SUBJECT: OYSTER CREEK NUCLEAR GENERATING STATION
DOCKET NO. 50-219
INVERTED POISON TUBES

Your letter dated September 28, 1973 indicated that insufficient data exists to conclude that poison redistribution cannot occur in control rods that may have inverted poison tubes. In this regard, you requested that we provide the information you require by responding to the seven questions listed in your letter.

Our response to these concerns are provided as Attachment I to this letter.

FIGURE 1
OYSTER CREEK - CYCLE 3 CONTROL ROD
NOTCHES INSERTED VS. CYCLE CORE
EXPOSURE - REVISED CALCULATION
BASED ON CONTROL ROD SOLUTIONS

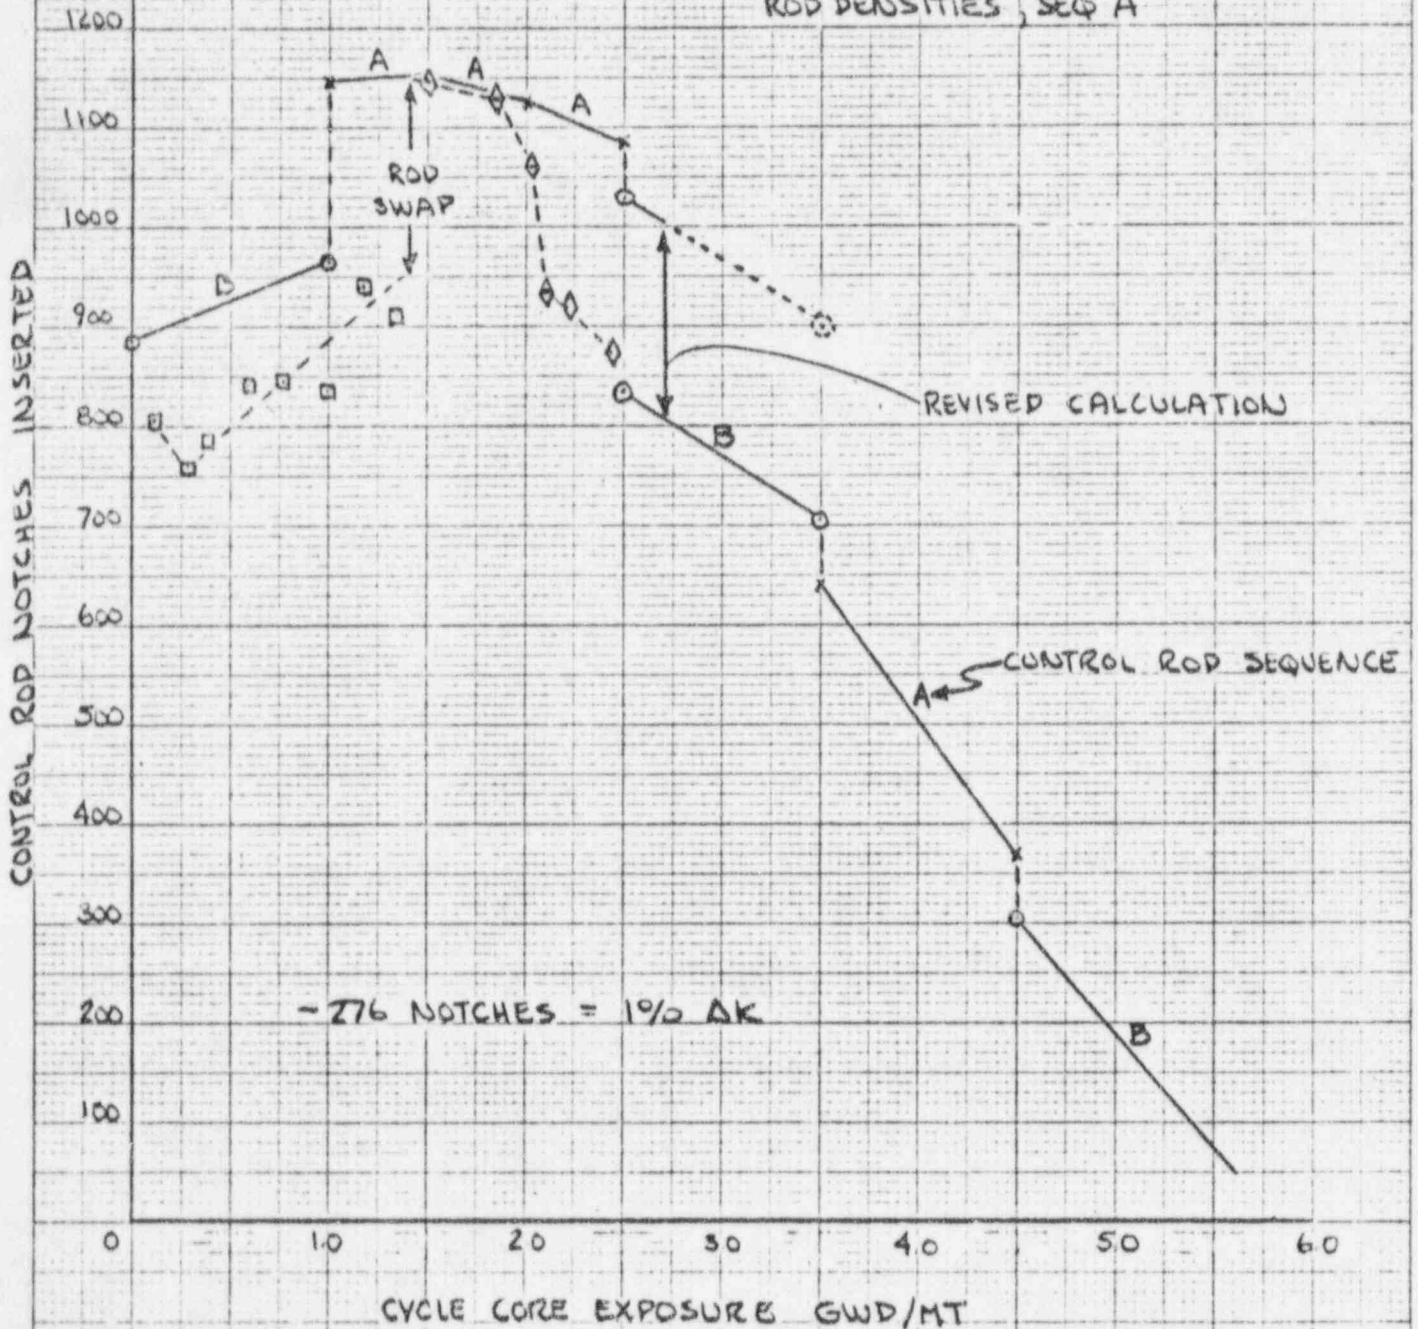
As a check, further scram calculations were made with effective control fraction from 1.0 to 0.7 in increments of 0.1. The results of these calculations are shown in Figure 1. From various pressure responses to scram reactivity curves it has been estimated that a degradation in scram reactivity from the 1.0 to 0.7 curve would result in peak pressure increase of three to seven psi, depending on the plant. This implies that a 0.8 effective control fraction would result in a peak pressure increase of two to five psi and 0.9 effective control fraction would result in peak pressure increase from one to two psi.

6. Submit the expected curve of reactivity vs. burnup for the remainder of the current operating cycle.

Figures 1 and 2 (attached) represent two calculational solutions of the reactivity curve at full power and full flow conditions. Control rod density vs. burnup provides the best measure of the core reactivity variation during the cycle. Figure 1 presents the results of control rod pattern solutions for the cycle. Note that the curve up to 2750 MWD/MT represents an original calculation. The rod patterns used for these predictions indicated more use of power shaping rods (hence higher rod density for the same rod worth) than was actually experienced. The use of power shaping rods was minimized in operation to minimize flux peaking off the control rods, hence, the MAPLHGR. The curve covering the period from 2750 MWD/MT to the end of cycle 3 represents a revised calculation based on adjusting the previous calculation for the reduced number of shaping rods and a slight correction for calculational bias found in the simulator eigenvalue prediction. A one percent variation in core reactivity is taken to be equivalent to 276 notches in all conditions.

Figures 1 and 2 also present a comparison of the actual to predicted control rod described for cycle 3. The plotted control rod densities are corrected for power, flow, and subcooling variations from those at full power and full flow.

FIGURE 2
OYSTER CREEK - CYCLE 3 CONTROL ROD
NOTCHES INSERTED VS CYCLE CORE
EXPOSURE - REVISED CALCULATION
BASED ON HALING SOLUTION

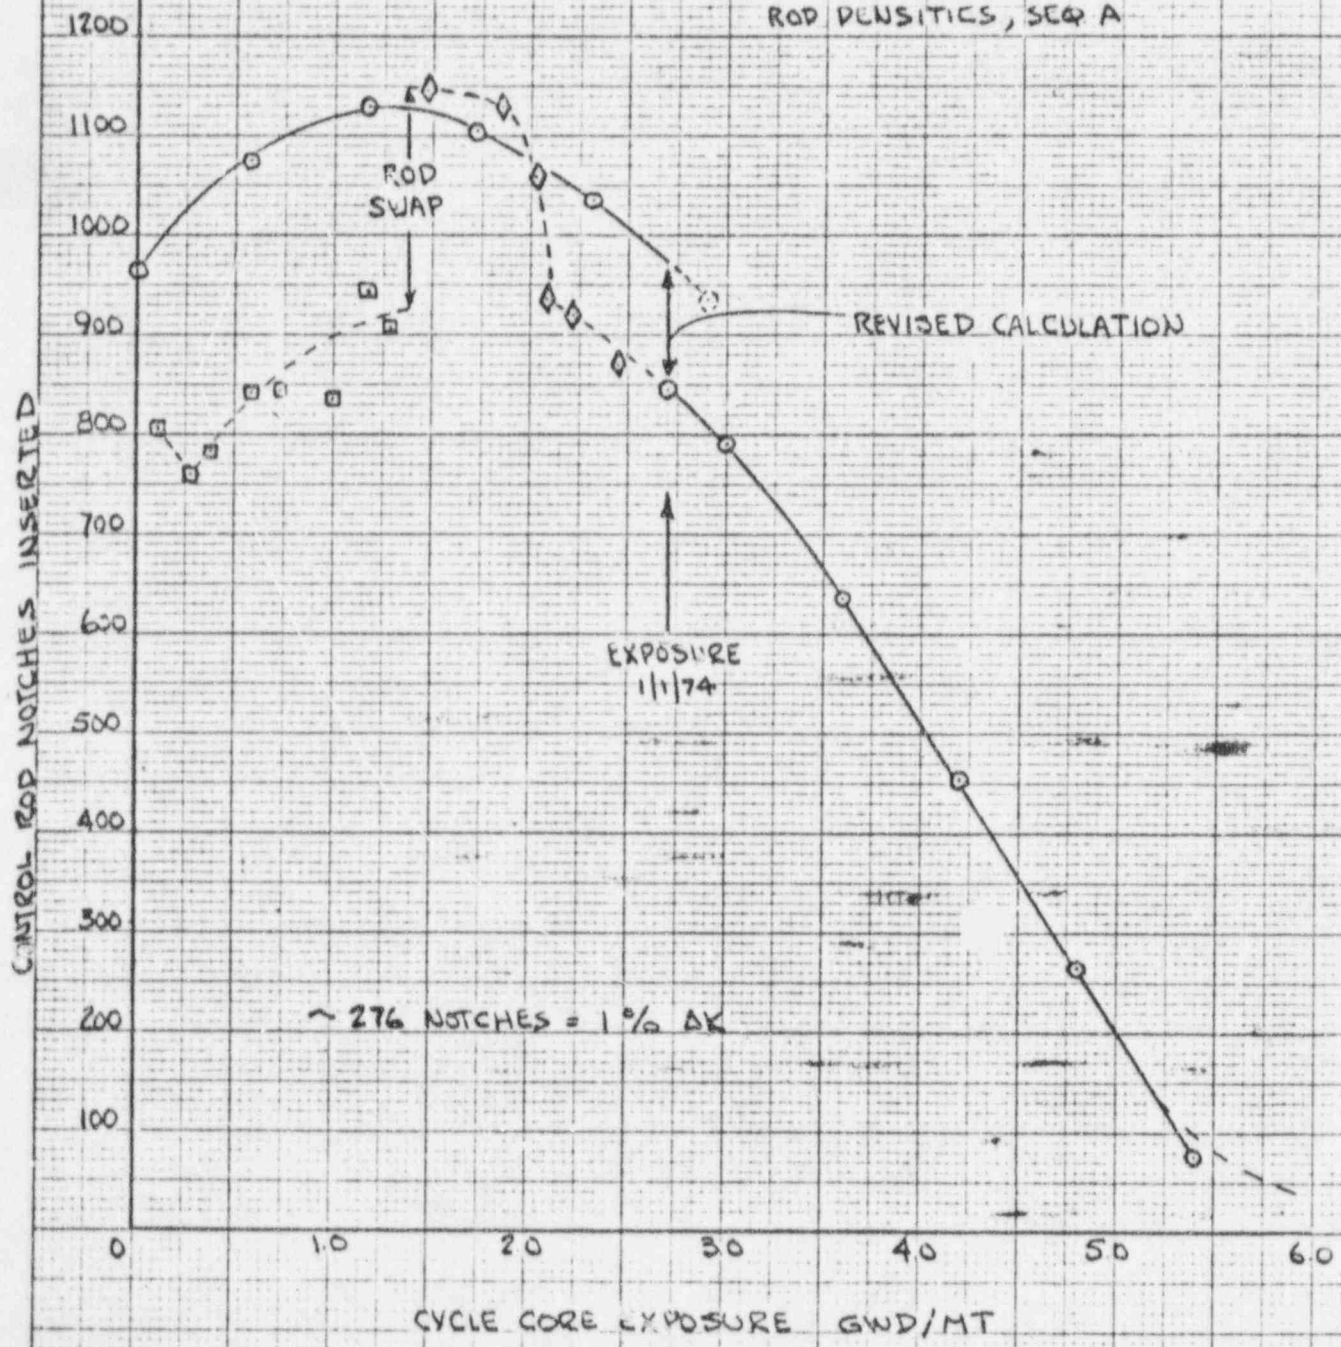
The effective control fraction in terms of defective absorber tubes (B_4C compacted ~16") then needs to be defined. This is shown in Figure 2. The curve was developed from bundle eigenvalues or more importantly loss in control strength for various numbers and positions of defective tubes. The experimental data given in "Results of KWU Critical Experiments and Proposed Control Blade Acceptance Criteria for Inverted Tubes" was used.

Figure 2 represents the results of a Haling type solution for cycle 3. Again, the first portion of the curve is the original result and the second portion (from 2750 MWD/MT on) represents a revised calculation. One would expect that Figure 1 represents a more realistic prediction since all effects possible (with the model used) are included in the calculation.

FIGURE 3

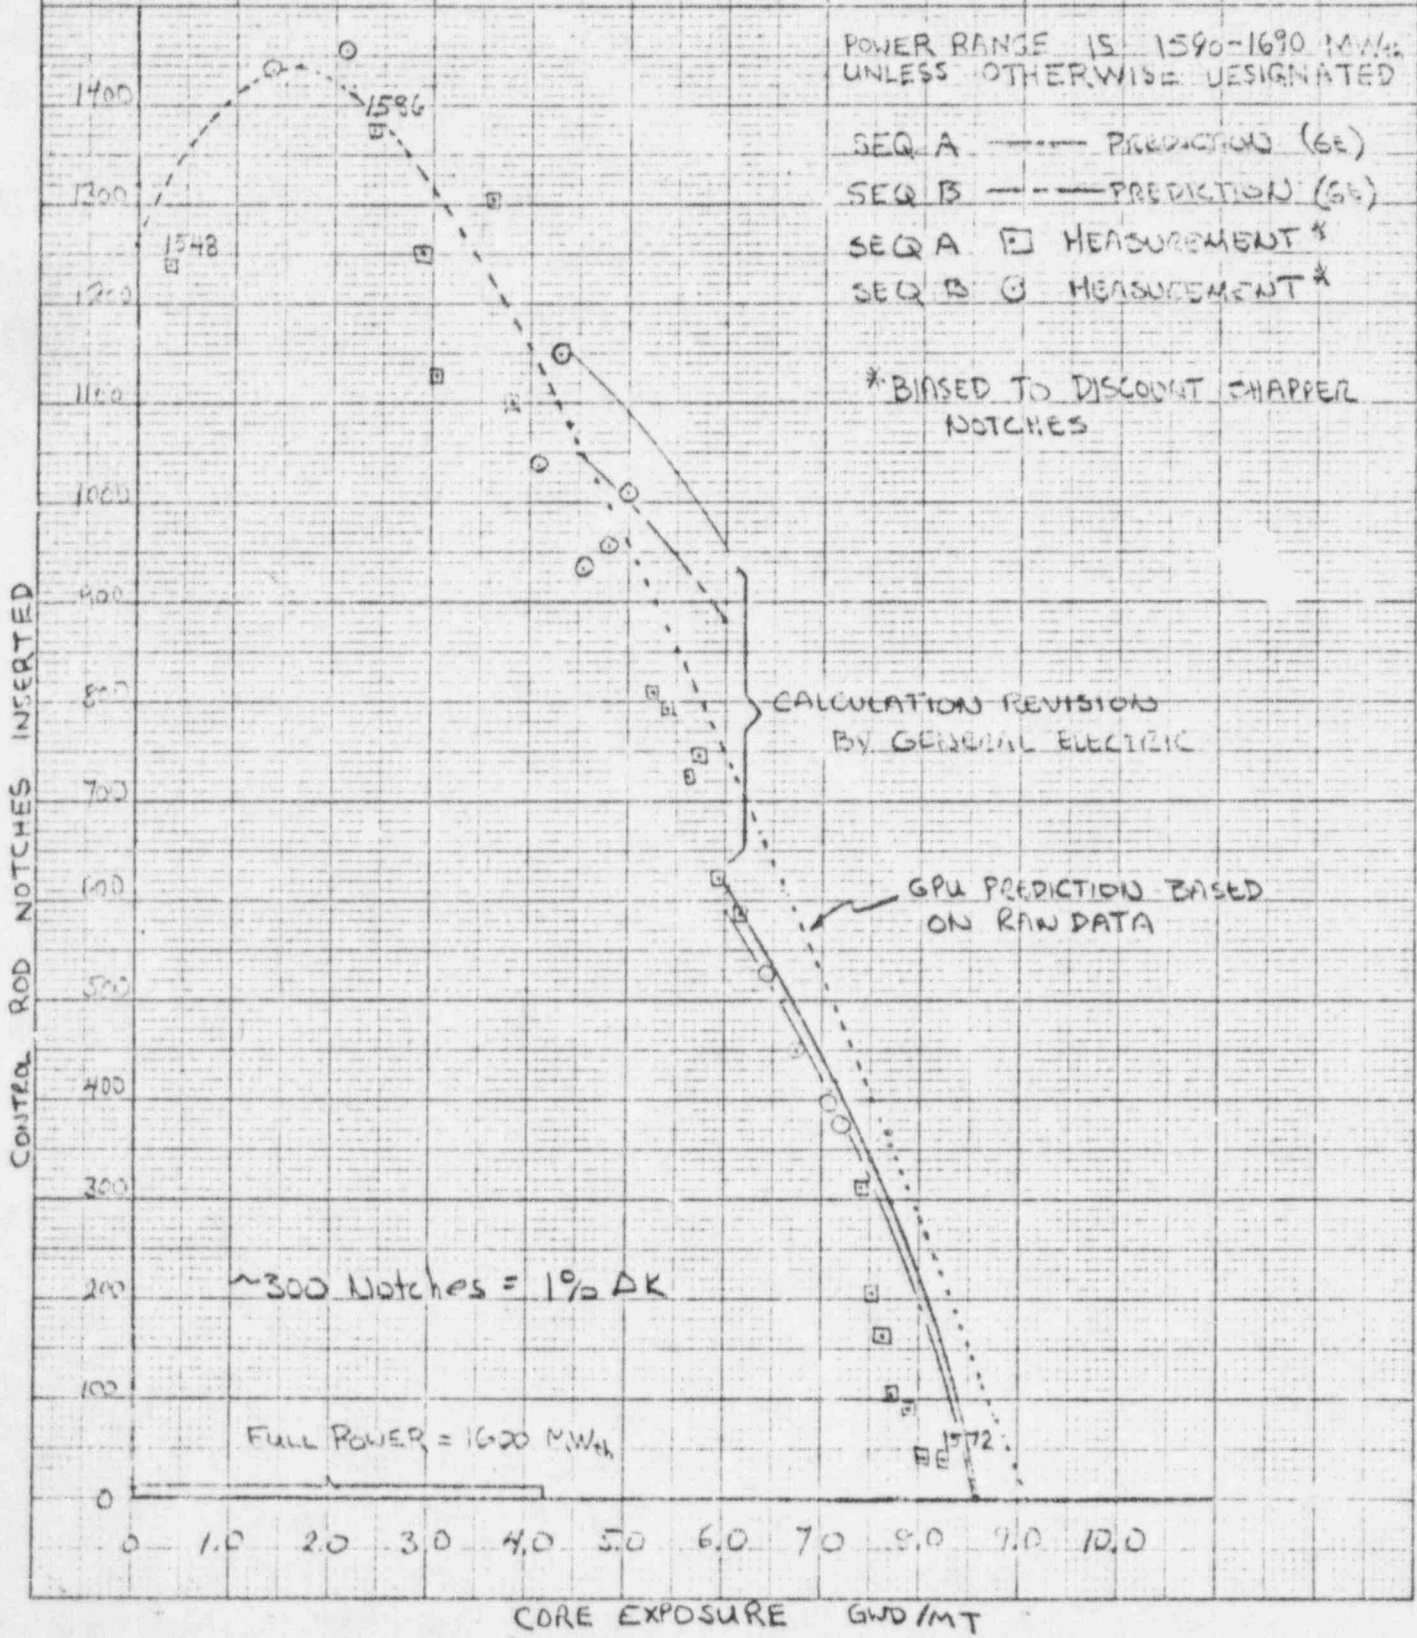
7. Provide a comparison of predicted vs. measured criticality measurements for the 3 fuel cycles at Oyster Creek, as well as a summary of the results of the control rod inventory checks required by Technical Specification 4.2.F including any corrections made to the predictions based upon previous data.

Figures 3, 4 and 5 present comparisons of measured and predicted control inventory for various cycle exposures for cycles 1A, 1B and 2 respectively. In all these figures the raw (base) data has been corrected for the number of notches inserted in power shaping rods.
